AMENDMENT

ETS 300 324-1

**This amendment A1 modifies
the European Telecommunication Standard ETS 300 324-1 (1994)**

**Signalling Protocols and Switching (SPS);
V interfaces at the digital Local Exchange (LE);
V5.1 interface for the support of Access Network (AN);
Part 1: V5.1 interface specification**

Page 237, figure L25.3, state "PATH INITIATED BY LE"

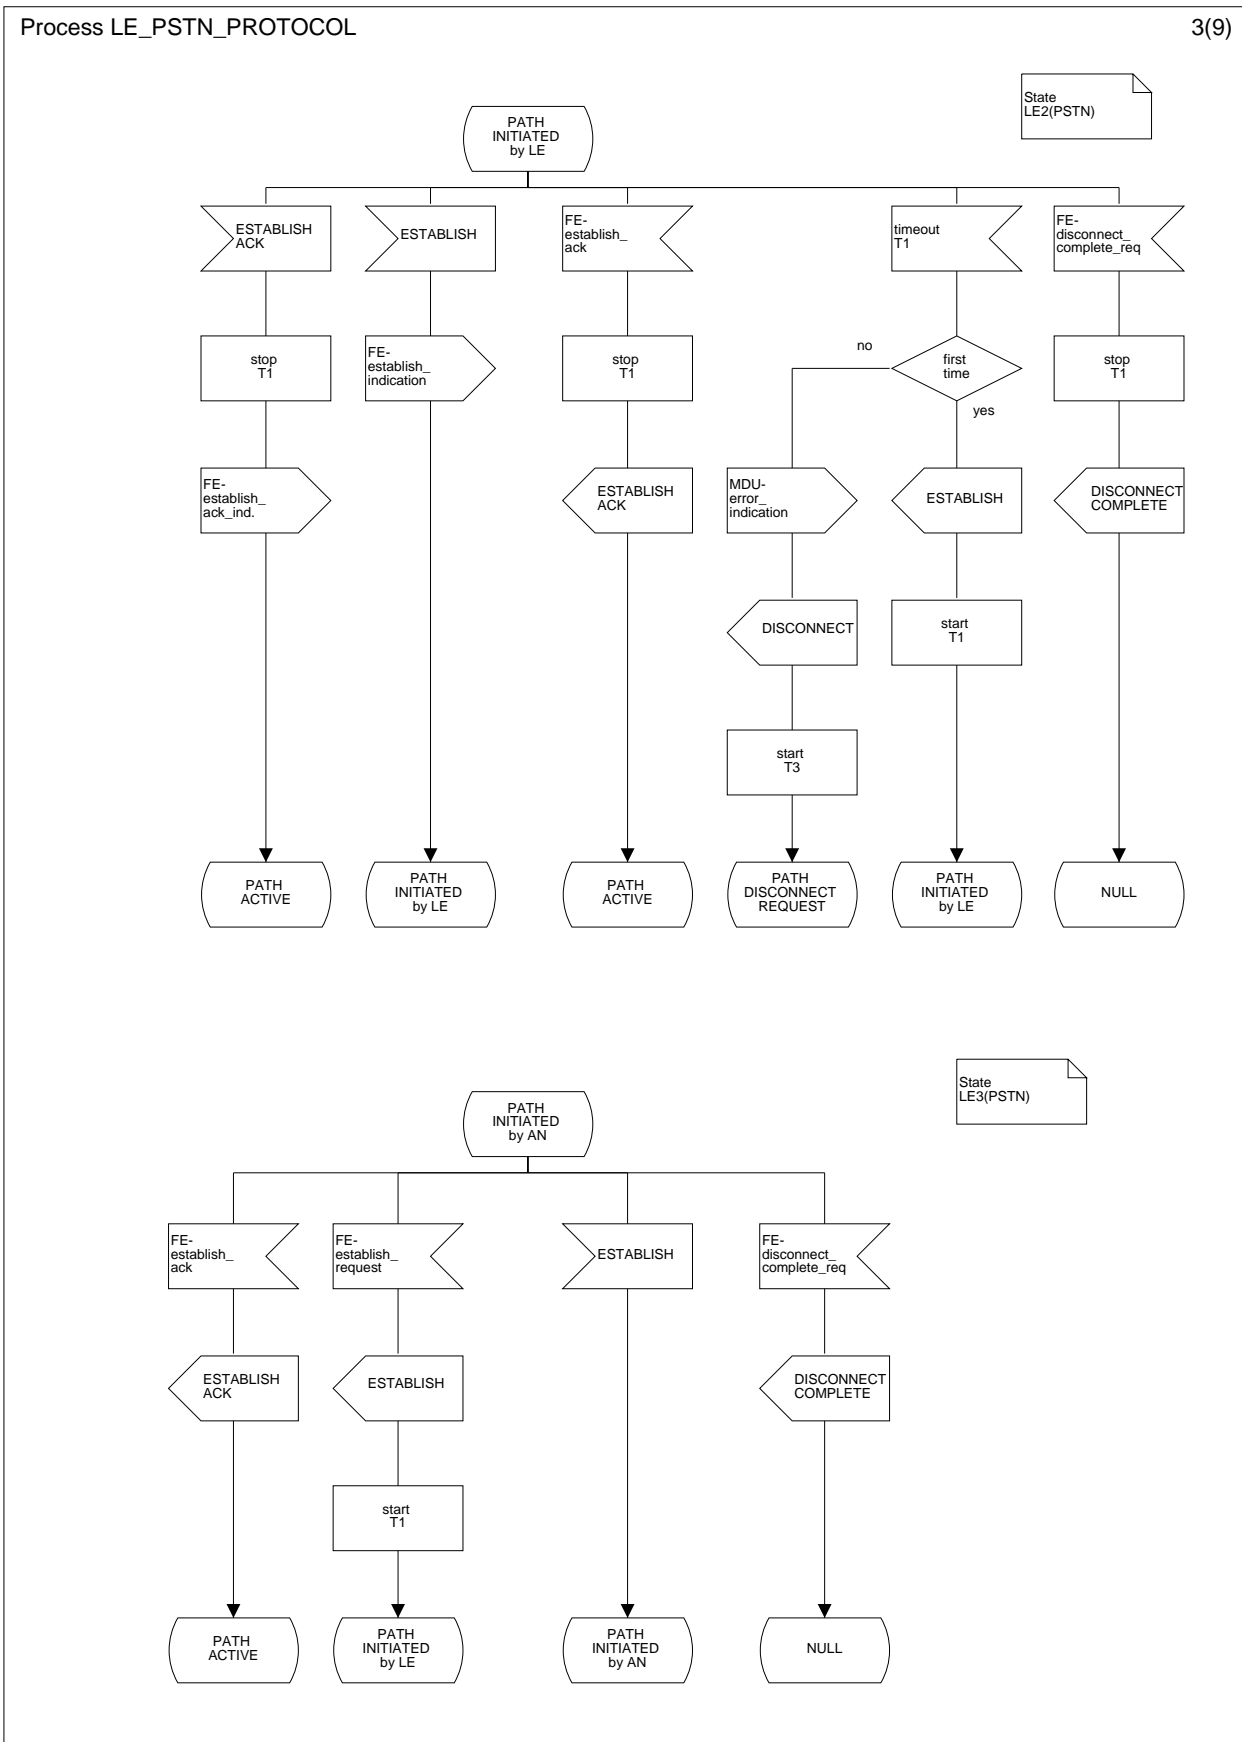
- Annex L, Figure L25.3: The handling of a call collision in the Line information case is not covered.
 Amendment: Show treatment of FE-disconnect_complete_request in state LE2.
- Annex L, figure L.27.1: Editorial error: The input symbol for PORT CONTROL ACK needs to be flipped.
- Annex L, figure L.27.2: Editorial error: Timer TO1 is misspelled.
- Annex L, figure L.33.1: Same as figure L.17.1.
- Annex L, figure L.33.2: Same as figure L.17.2.
- Annex L, figure L.33.5: This figure is not in line with annex C, item 12). MDU-CTRL (blocking started) is missing.
 Amendment: Update of figure L.33.5 to include MDU-CTRL (blocking started).
- Annex L, figure L.33.7: Same as figure L.17.7.

Add a new branch "FE-disconnect_complete_request" as shown below

Page 241, figure L.25.7, state "PORT BLOCKED"

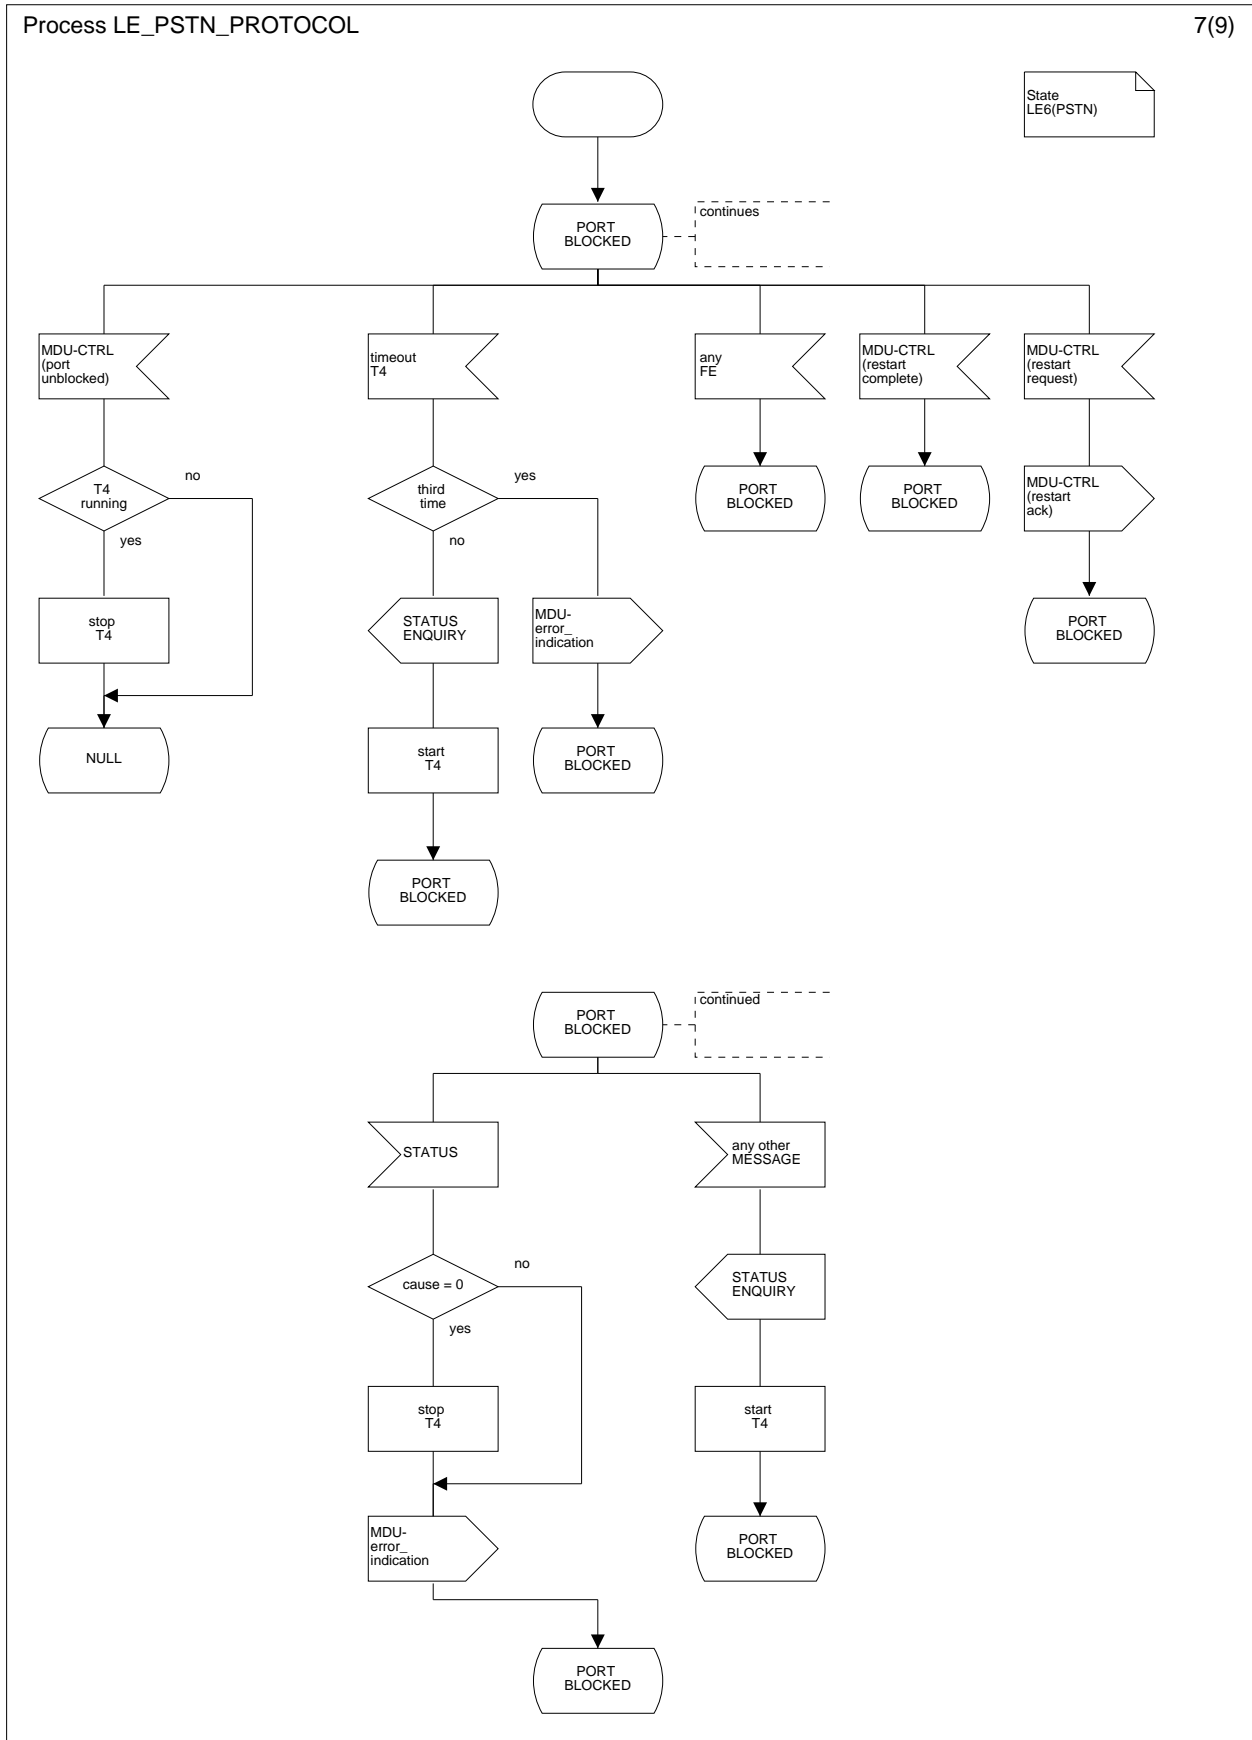
Add the start symbol and a transition to "PORT BLOCKED".

Page 245, figure L.27.1, state "IN SERVICE"

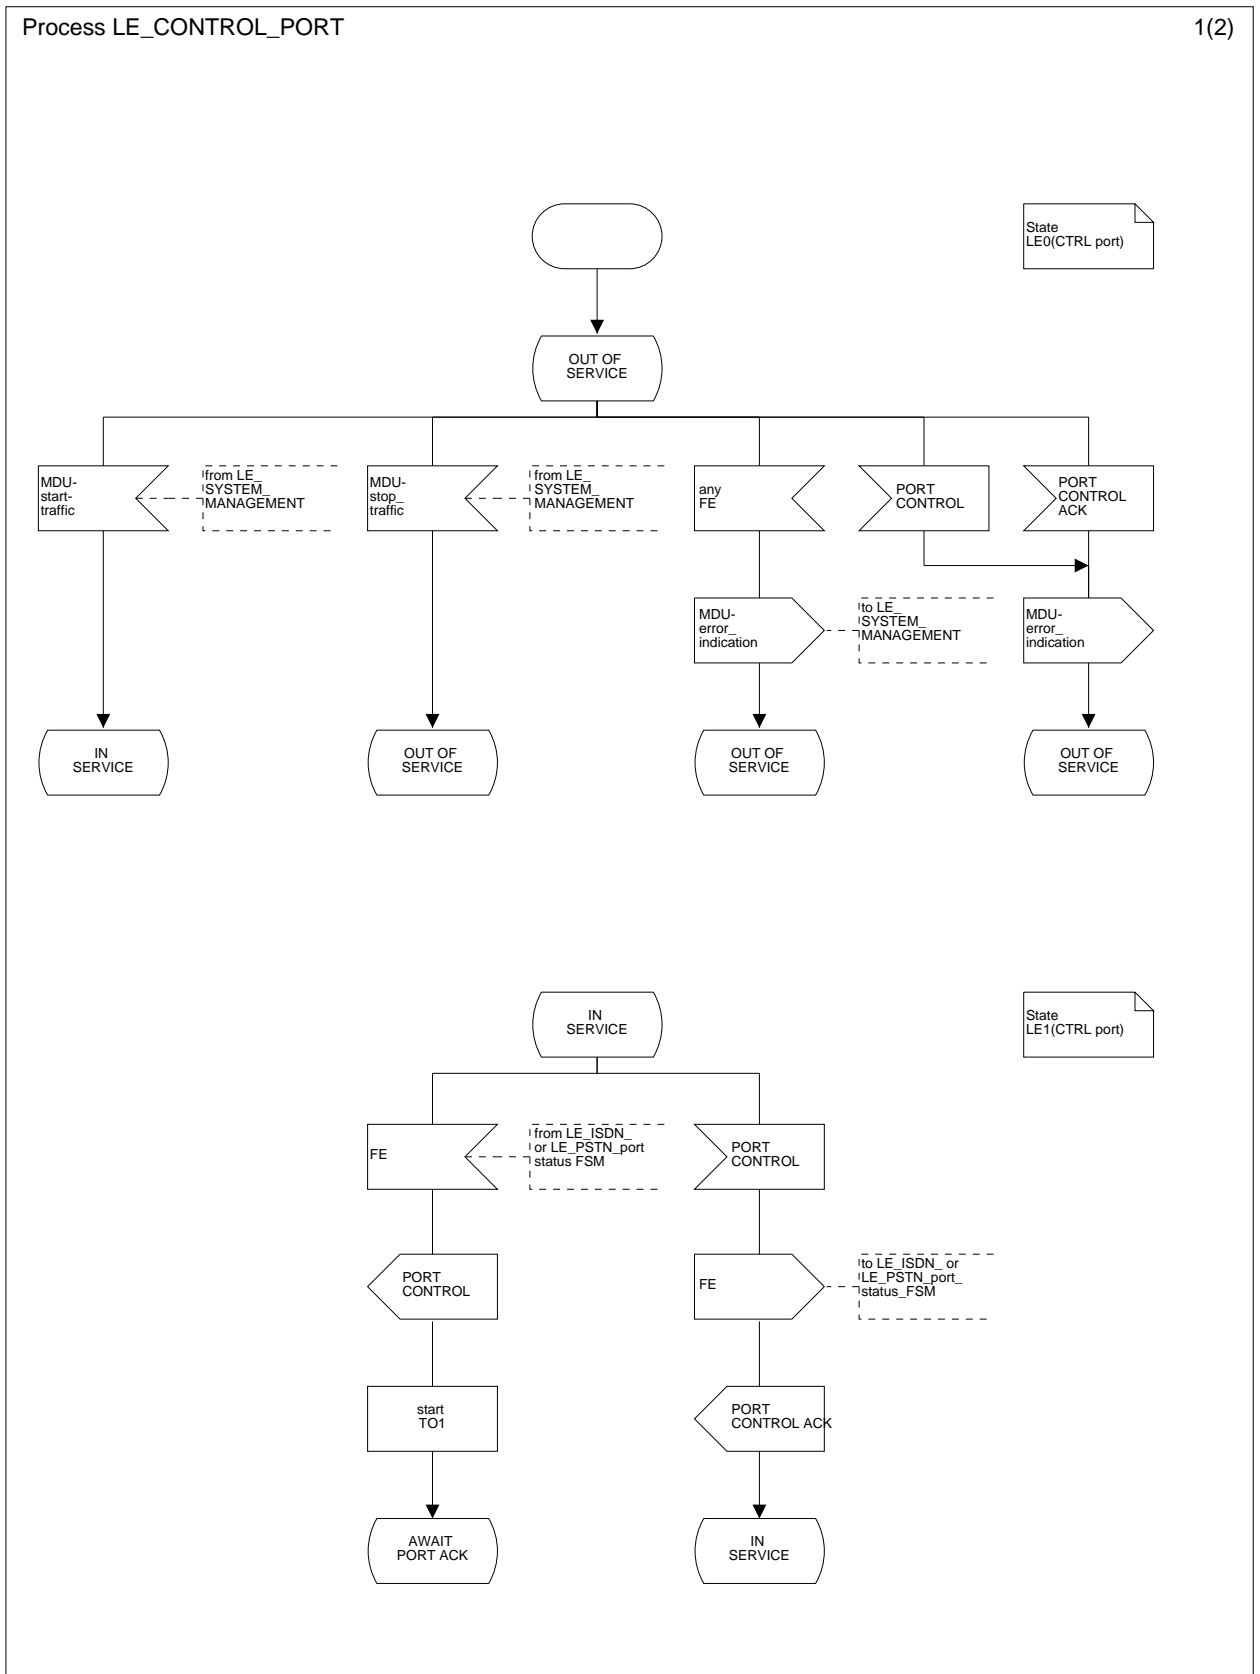
Flip the input symbol "PORT CONTROL ACK".

Page 246, figure L.27.2, state "AWAIT PORT ACK"

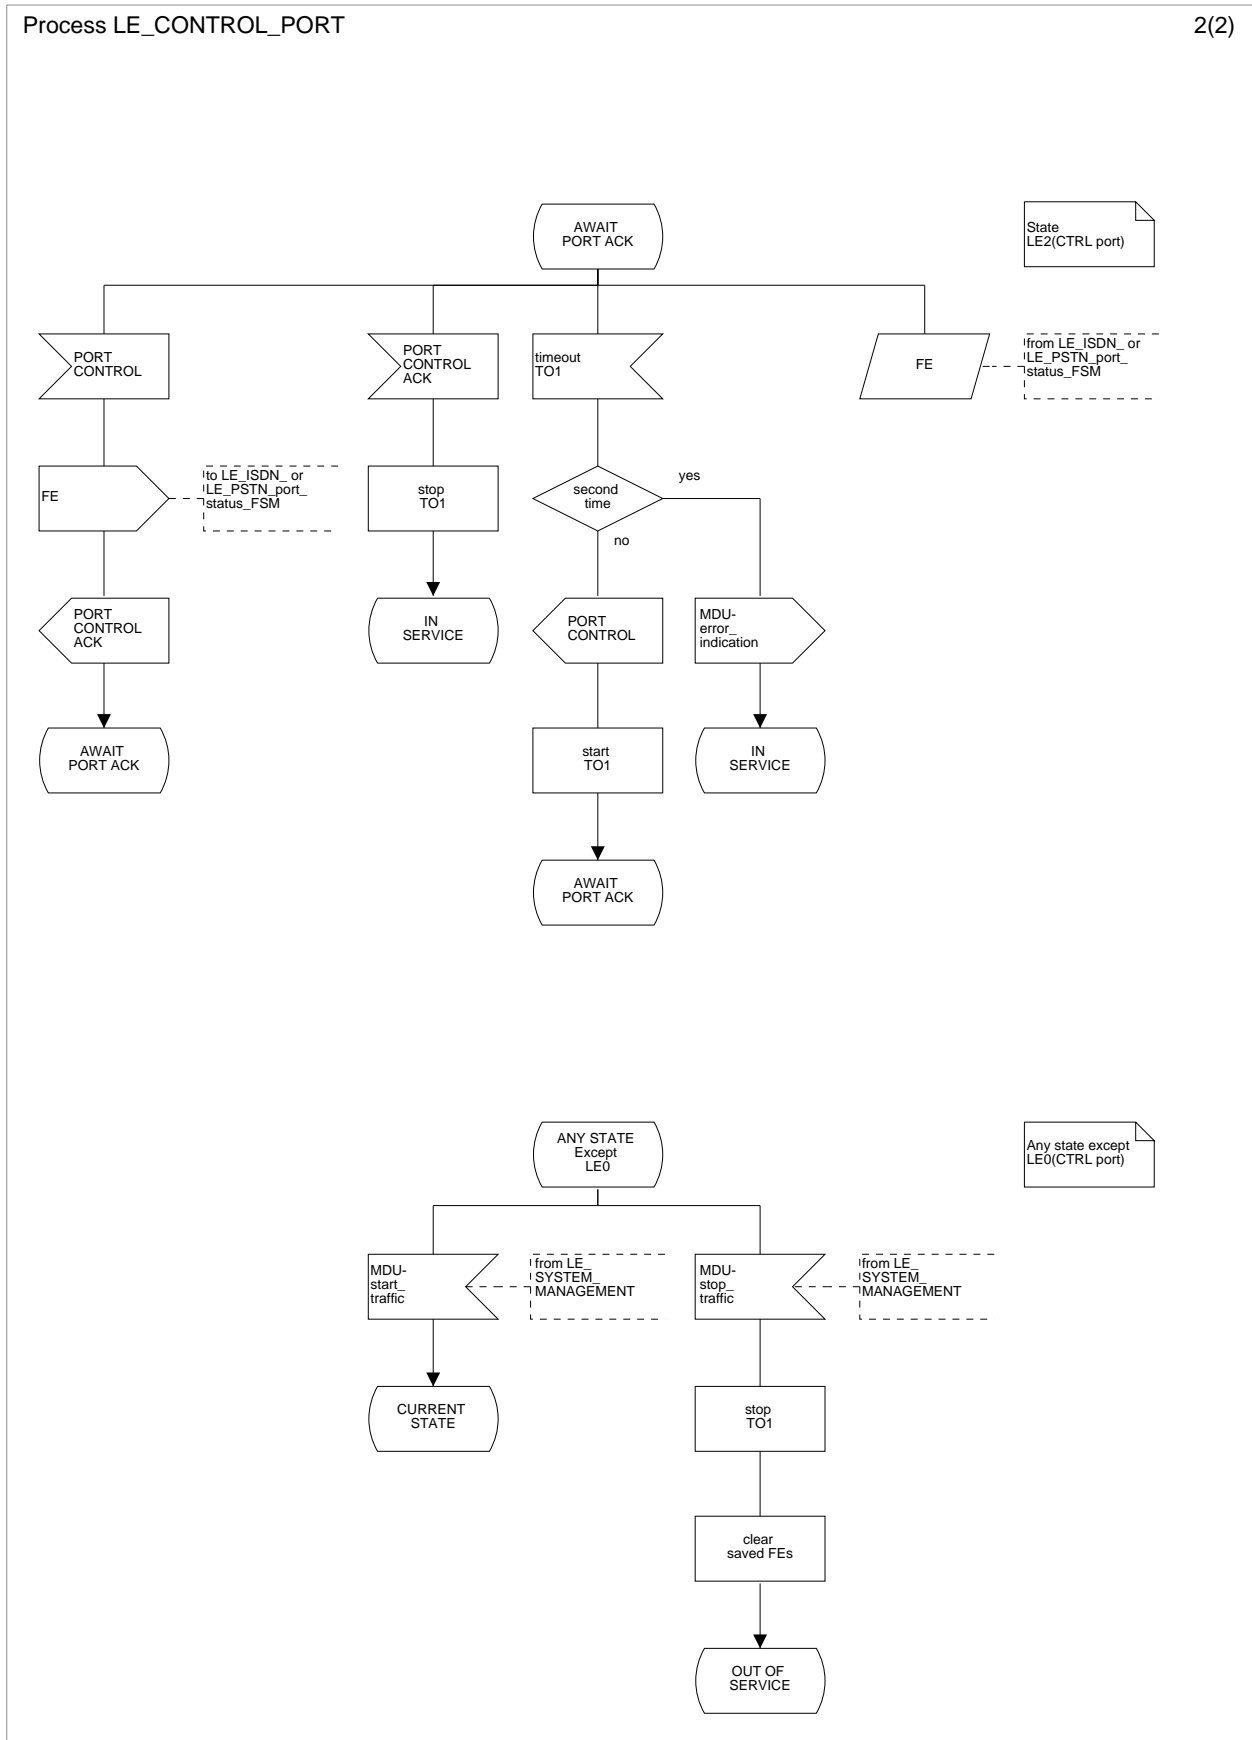
Correct the event "timeout TO1".

Page 259, figure L.33.1, state "SYSTEM STARTUP"

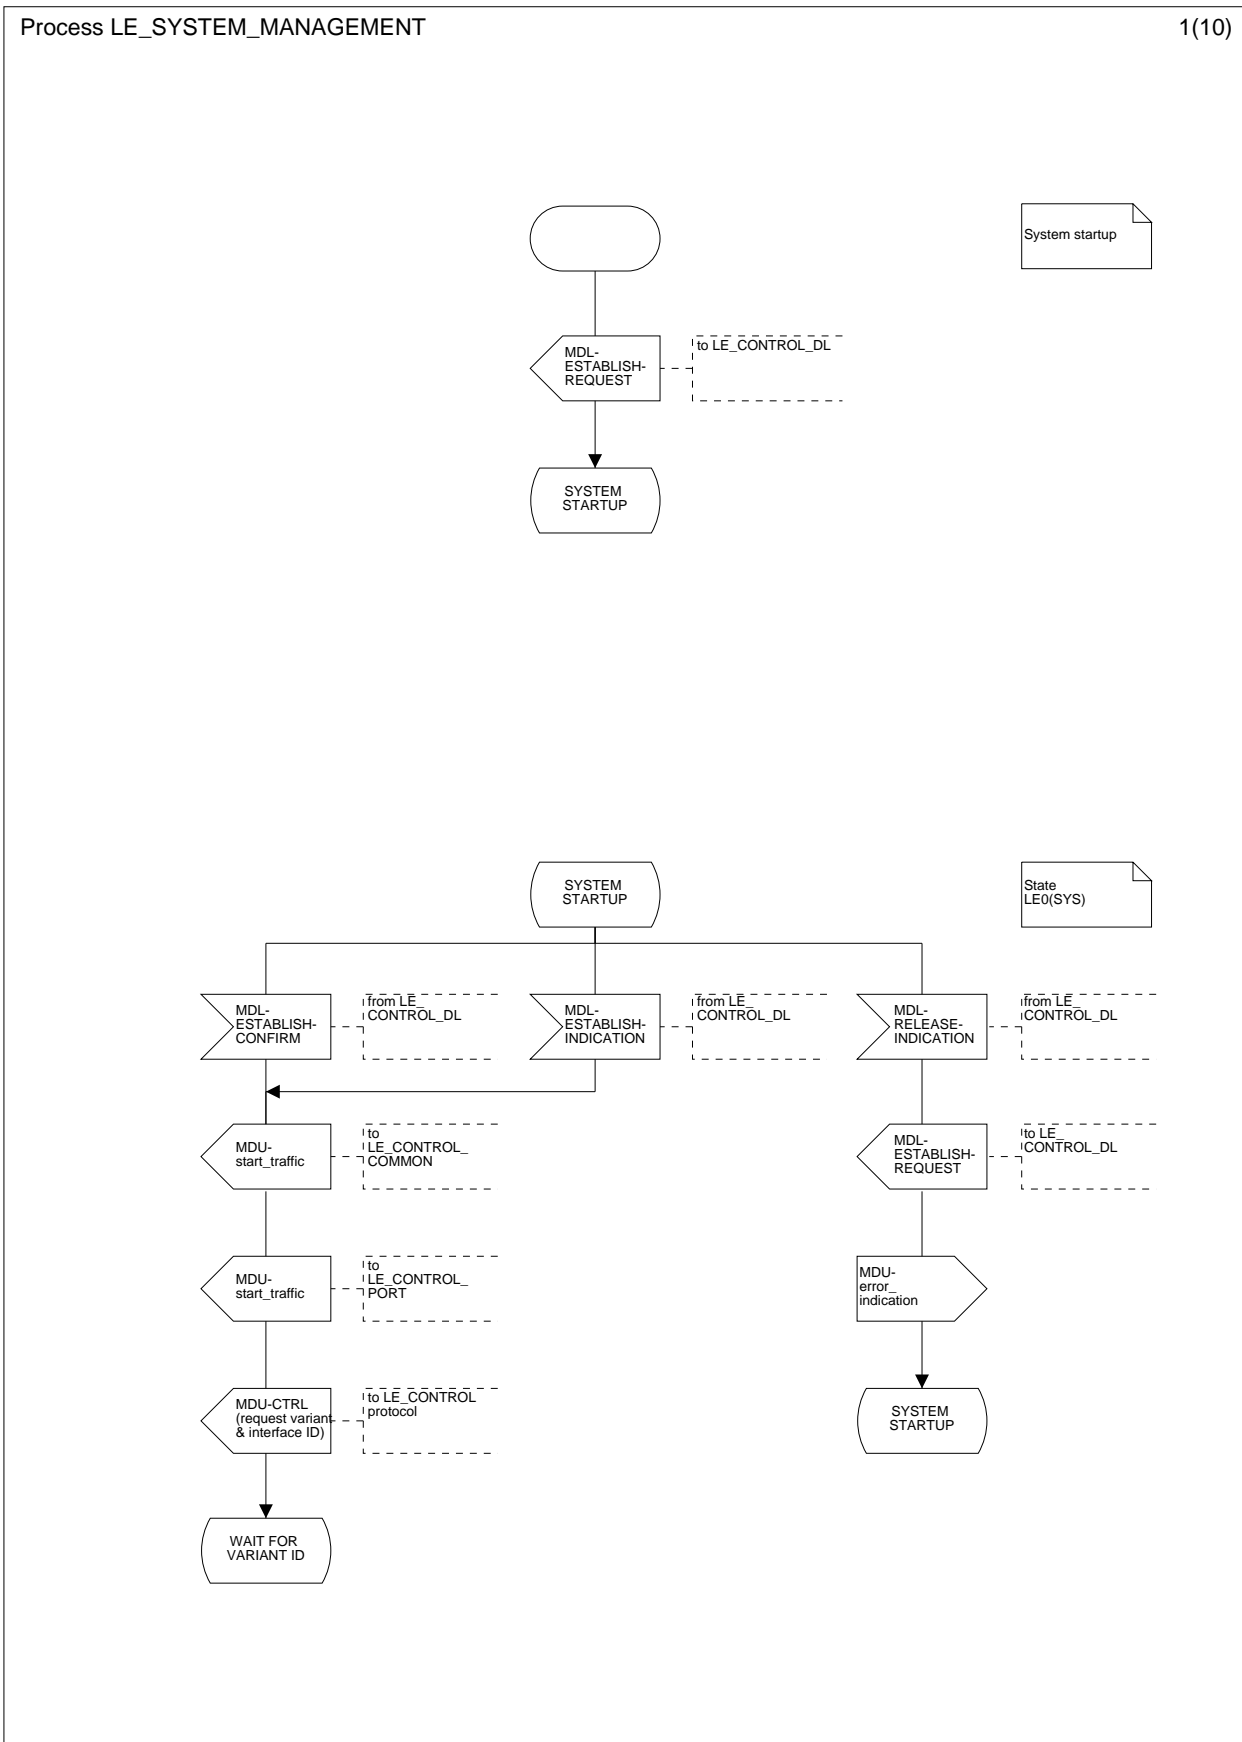
Add a new branch "MDL-RELEASE-INDICATION" as shown below.
